# CITY MINISTRIES PUD ZON06-00021

ZON06-00021: City Min PUD

### DEVELOPMENT STANDARDS LIST

File: ZON06-00021, City Ministries PUD

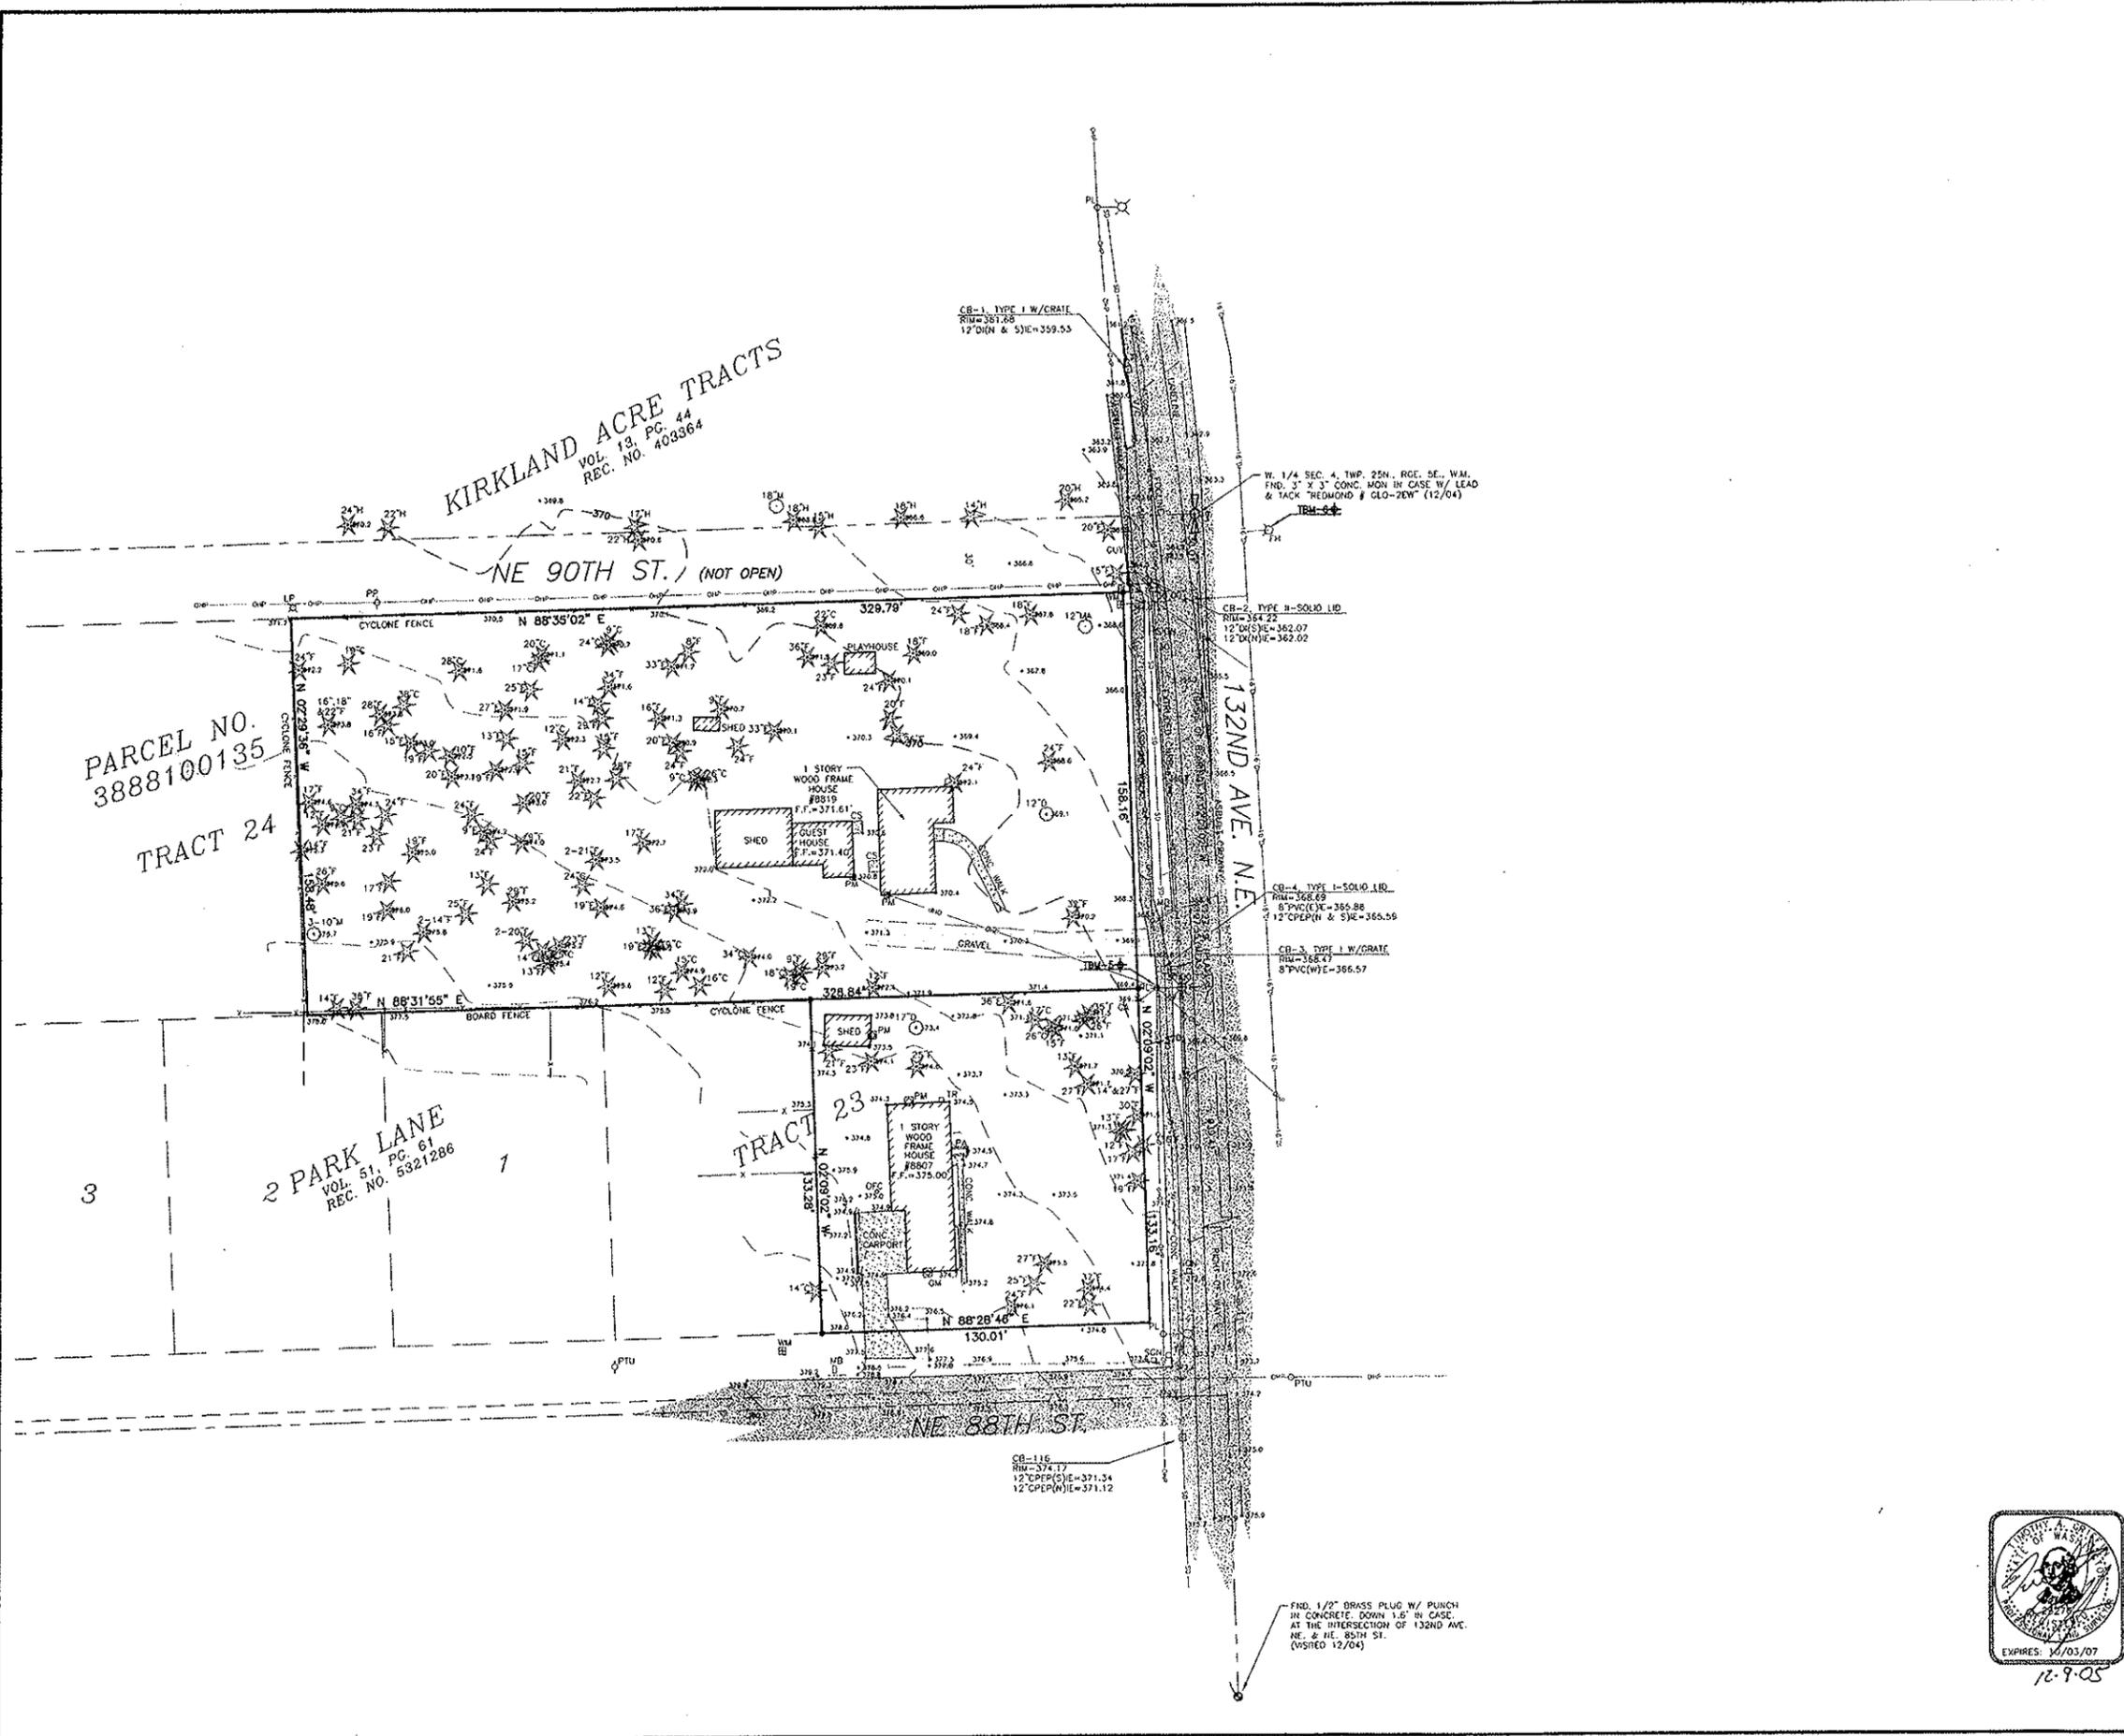
1. As depicted on sheet C2 of the plan submittal, extend an 8-inch sewer main from the new sewer main in NE 90th St, south through the project parking lot and then east on NE 88th Street to 132nd Ave. NE. The sewer main through the parking lot shall be encompassed in a 20 ft. wide utility easement.
2. Provide a plan and profile design for the sewer line extension
3. The existing septic system shall be abandoned per City standards.
4. Provide a 6-inch minimum side sewer stub to each unit.

1. The existing water main in 132nd Ave. NE and NE 88th St. is adequate.
2. As depicted on sheet C2 of the project submittal, loop an 8-inch water main through the site between the water main in NE 88th Street and NE 90th Street. The water main shall be encompassed in a 20 ft. wide utility easement (the same easement for the sewer main).
3. Replace the 6-inch water main in NE 88th St. with an 8-inch water main from 132nd Ave. NE to the new 8-inch loop through the site (depicted on sheet C2).

4. Provide water service to the project per the Uniform Plumbing Code.
5. The existing water service may be used provided that it is in the right location, is not galvanized, and is sized adequately to serve the building (per the Plumbing Code).
6. Per the Fire Departments request, provide a new hydrant within the site off of the new 8-inch water main loop.
